**123-127 Bellevue Ave E, Seattle WA 98102**  
**3034556-LU**  
**Design Review Packet II - Revisions**  
**July 28, 2021**

RESPONSE TO EDG REPORT  
123&128 BELLEVUE AVE E,  
SEATTLE WA 98102

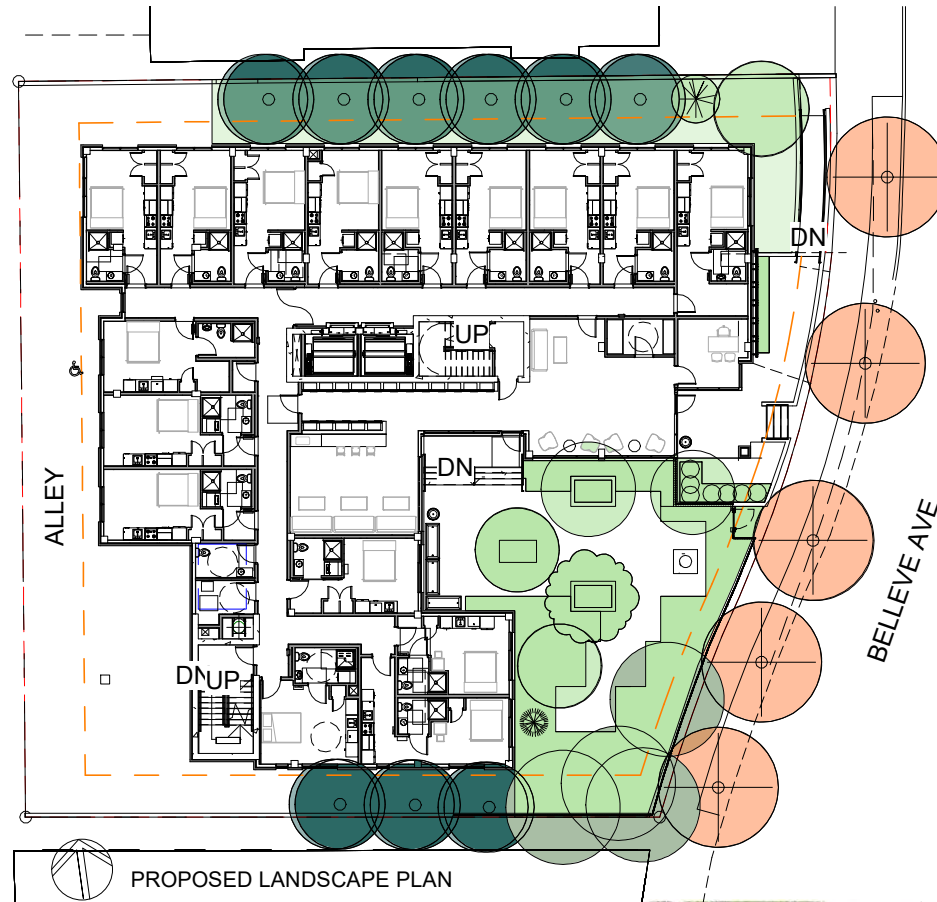
- a. After reviewing the three different massing options, staff recommends developing a new massing option that builds on the successful elements of Options 1 and 3, described in further detail below.

- b. Staff broadly supports the idea of bringing the building down to street grade, as shown in Option 3, which is consistent with the neighborhood pattern and provides a stronger connection to the public realm that is more appropriate for a building of this scale. However, in agreement with public comment, staff does not support removal of the grove of trees. The applicant, in consultation with their arborist, states that the trees cannot survive the grading required to bring the building down to street grade. As a possible solution, staff recommends studying an alternative that brings the northern portion of the building to street grade while maintaining existing grade at the southern end to allow for retention of the grove. (CS1-C-1, CS2-B-2, CS2-C-2, PL2-A-1)

- c. The adjacent site to the south is developed with a 110-year old three-story multifamily residence. While the zoning allows for more intense development, the proposal has a responsibility to successfully integrate with its existing context. Options 1 and 3 shift massing away from the southeast corner of the site, providing the most relief for the significantly smaller building to the south. Staff acknowledges public comment concerns with the proposed height compared to nearby context. As the proposal is further developed, maintain a respectful relationship with this smaller structure. The retention of the grove also enhances the relationship between the two properties by screening and softening the transition. (CS2-D-1, S2-D-2)

- d. Staff acknowledges the potential for privacy impacts raised in public comment. As the design is further developed, study potential privacy impacts with particular attention to window locations and decks. Provide window overlap privacy diagrams at the Recommendation phase. (CS2-D-5)

- e. Staff agrees with the concerns raised in public comment regarding the height of the structure and shading impacts. Locate and design rooftop structures (e.g. stair penthouses) to minimize their appearance from the public right-of-way and shading on adjacent properties. Use modulation on the primary structure to reduce perceived height and improve solar access. (CS1-B-2, CS2-D-1, DC2-A)

The proposed design has been achieved by a careful study of the impact of the building on all sides of the site. The existing grove is situated precariously on the southern end of the site, with a retaining wall that is barely holding up the steep sloped dirt from the site to the neighbours on the south. The EDG recommendation asks for the study of an alternate option where the grove would be retained towards the southern half of the site and the building would be brought down to grade on the northern part of the site. However, further study of the grove reveals that the existing retaining wall to the south of the site is failing. Hence in lieu of the potentially unsafe existing grove with the invasive species, we suggest a grove like landscaped feature at the level of Bellevue Ave, making a strong connection with the street and public realm. This would be achieved by setting the building further back at the level of Bellevue Ave to allow for more landscaping facing Bellevue Ave. This grove would extend into the space between the 110 year old multifamily residence and the site to act as a screen between the two sites. The new proposed trees and plants will be native, naturally growing plant species of this area. The main door will be accessed from Bellevue Ave and be accessible to all.

The project site is located in the middle of a block and the proposed building has setbacks more than required by code, between the buildings on the north and south. The project tries to be respectful of the scale of the building to the south and has very few windows on that side, facing this building. The windows in the units to the north and south will be shielded from the windows of the neighboring buildings by tall, columnar trees (Frans Fontaine Hornbeam) that grow upto 40' high.

SOUTH EASTERN VIEW OF SITE. FOLIAGE NOT SHOWN FOR CLARITY.

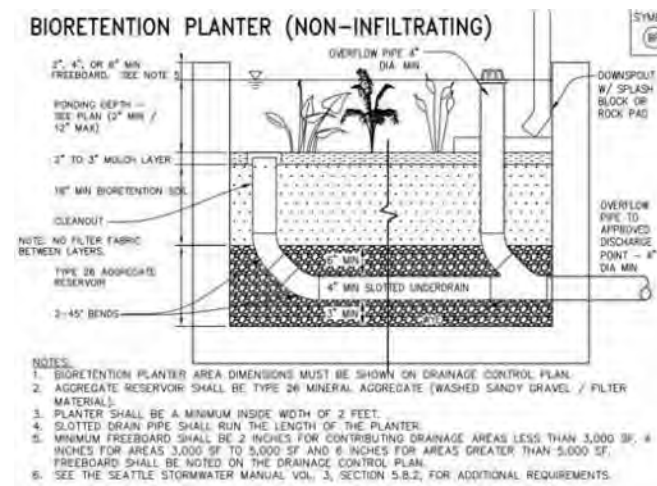
a. The grove at the front of the site is a valuable existing condition that should be not only preserved but celebrated. As the architectural concept is developed, seek out opportunities to integrate the grove into the design itself. Allow the existing trees to inform the massing, architectural concept, materials, landscaping, and amenity areas. (CS2-A-1, CS2-B-1)

b. The EDG packet describes the applicant's anticipated material strategy, which would utilize a masonry or wood-like material at the base and contemporary materials above. However, the massing options do not include a pronounced change in plane at the lower levels; in other words, there is no base within the massing itself. Public comment also requested additional modulation and secondary features. Staff supports the concept of having a distinct base with a material change, but the base needs to be accompanied by a physical shift in the massing, not just in the material application. As the massing is further developed, material application should be considered in concert with massing so that material changes correlate to a change in plane. (DC4-1-a)

c. The Capitol Hill neighborhood specific design guidelines call on applicants to integrate sustainability features as well as references to the local culture and history. It is unclear from the EDG packet if the applicant is proposing any such features or references. Seek out opportunities to add sustainable features, particularly those that can be integrated into the design concept, and incorporate cultural references into the proposal. Call out any such features in the Recommendation packet. (CS1-1, CS1-2, CS1-4, CS1-5, CS3-2, CS3-3, DC4-2)

*The new proposed grove at the level of Bellevue Ave is an integral part of the design. It gives a sense of place to Bellevue Ave, while creating a landscaped courtyard as an amenity space for the residents of the building*

*As shown in the views, the proposed design takes into account the EDG comments and creates a material and physical shift in the massing of the building between the 2nd and the 3rd floors. The design also proposes a variation in plane through a terrace room area on the top most floor.*

*Sustainable features like passive ventilation through operable windows and creating new habitats, use of native, naturally growing plant species, a diverse planting palette and bioretention planters for dealing with rainwater are all part of the design. A living wall at the entrance to the building integrates with all the other landscape elements to create a green edge along the site on Bellevue Ave.*

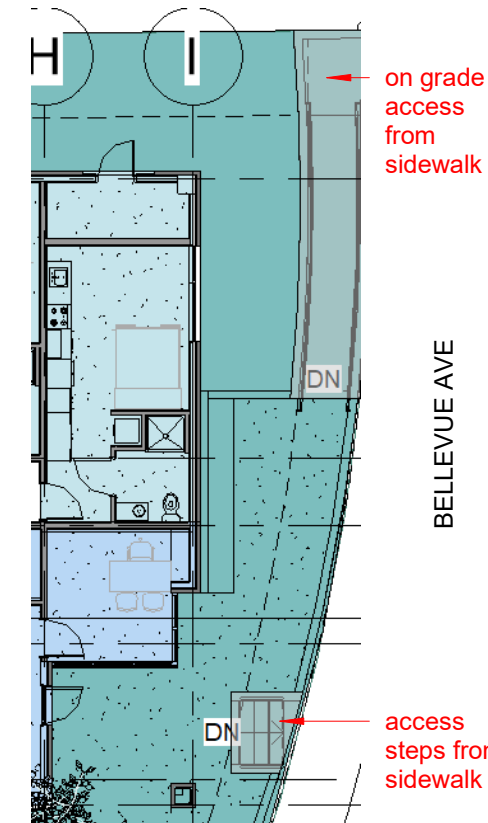
a. Design the main residential entry to be obvious, make a strong connection to the street, and of an appropriate scale for the proposed eight-story height. (PL3-A, PL3-1-b)

b. Ensure that the main residential entry is easily accessible to all tenants and visitors. Avoid access ramps to the extent possible and integrate any such ramps thoughtfully into the architectural concept. (PL2-A-1)

*The entry to the building is marked by a green wall and is under a projecting volume of the 2nd floor. Steps and on grade access are integrated into the landscaped area in front of the building on Bellevue Ave.*

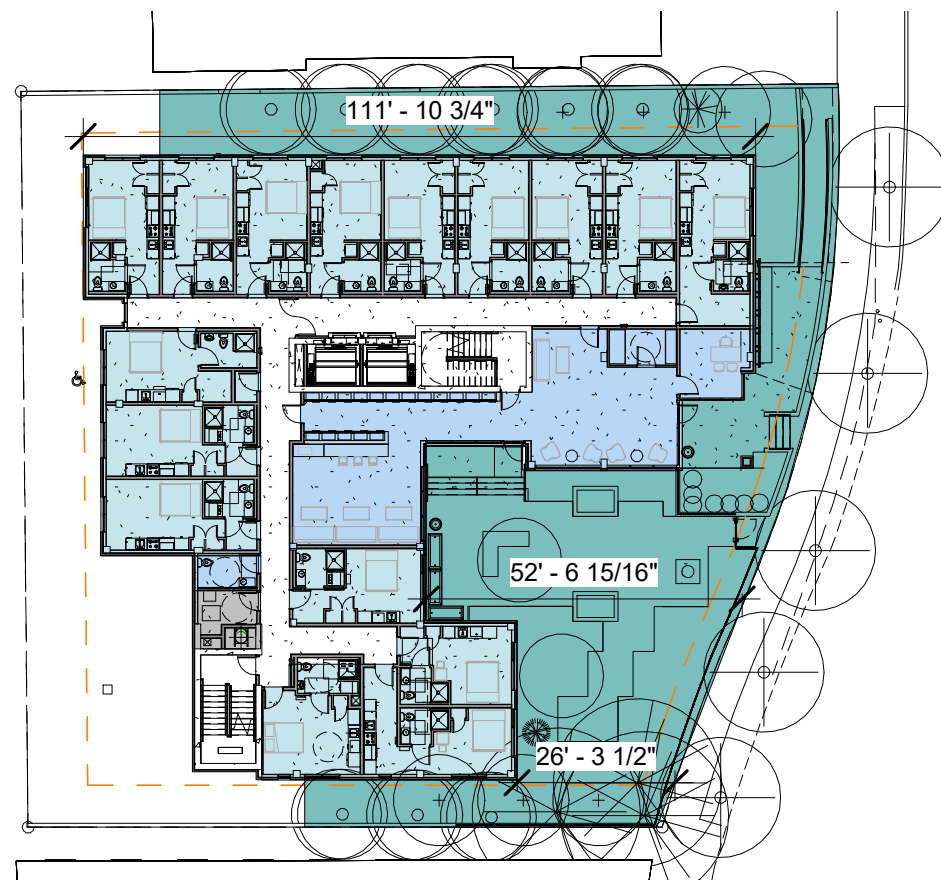
a. As the proposal is further developed to retain all or most of the exceptional trees on site, staff identifies retention of the parking area as a low priority and supports its removal in service of other project goals. (CS1-4-e)

*The proposed design dedicates large areas to landscape and trees, to create a sense of place on Bellevue Ave. 8 parking spots are provided with alley access.*

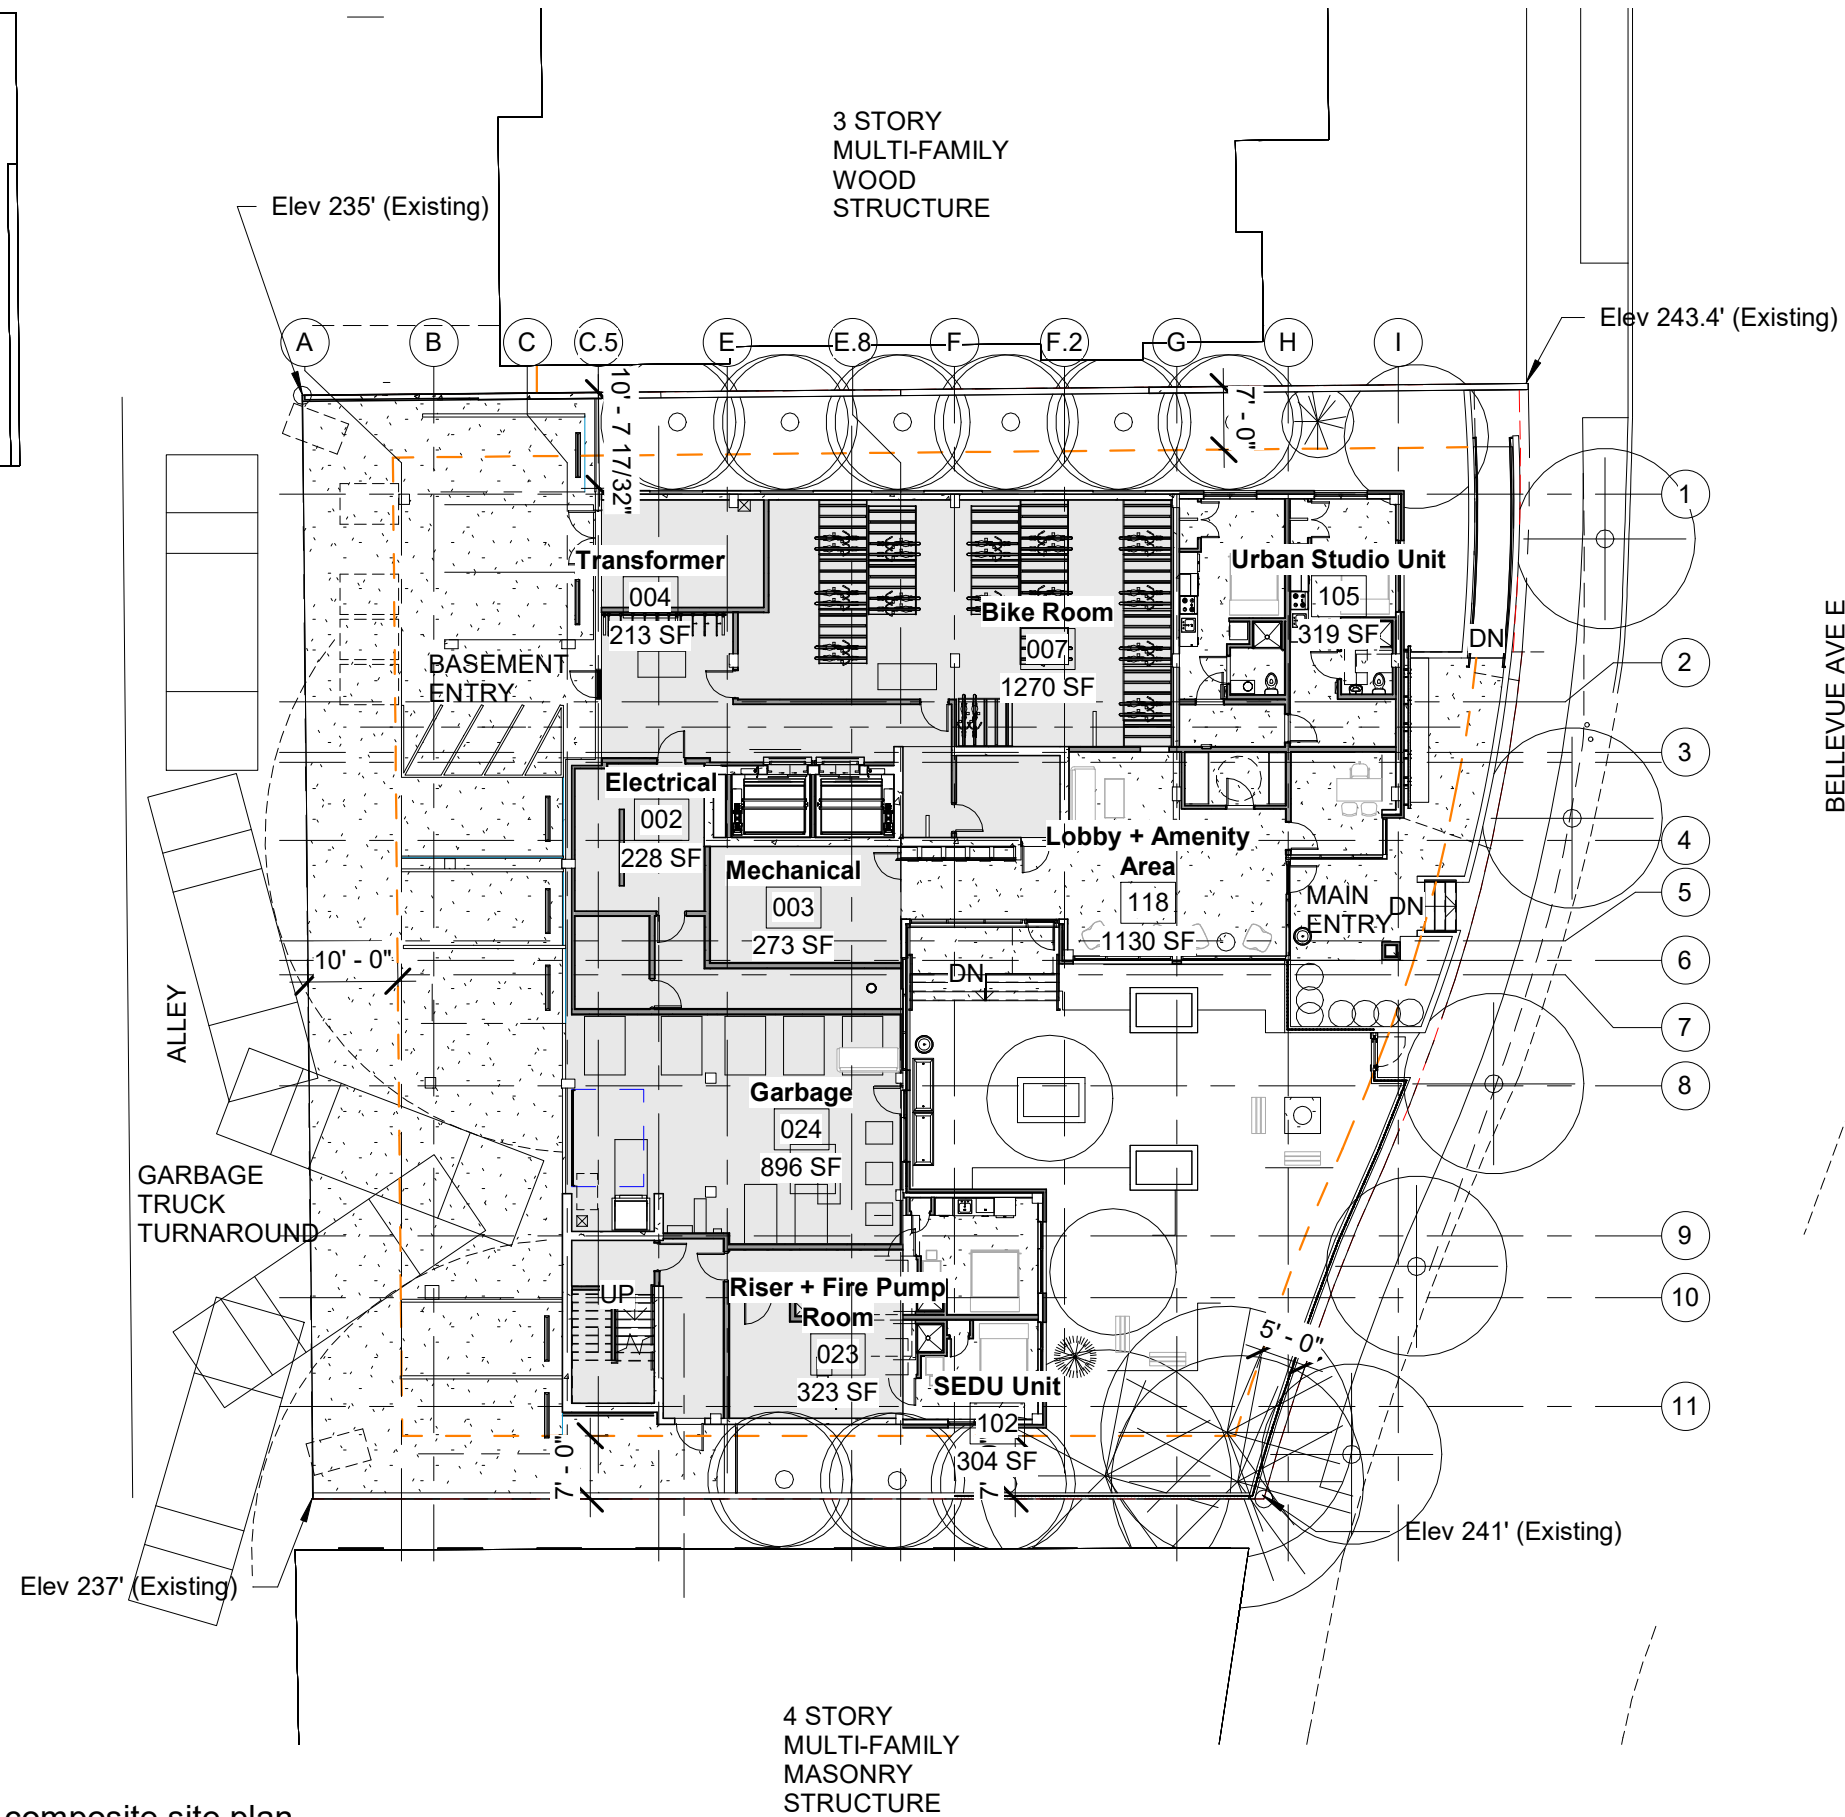
Staff indicated that based on the guidance provided in this EDG report, the massing and site layout shown at MUP are anticipated to differ significantly from what is shown currently. Staff expresses preliminary support for the departure as described, which allows for a plaza-type amenity at the front of the proposal, but notes that given the significant changes expected in response to Early Design Guidance, this departure will need to be fully reexamined at MUP.

The proposed design has a grove of trees proposed as a feature in the front of the site along Bellevue Ave along with a landscaped courtyard,, which is achieved by pushing the building 52' at the maximum and 26' at the minimum. The proposed design would require a departure from the limit on the depth of the structure from 108'8" to 111'11" along the northern edge.
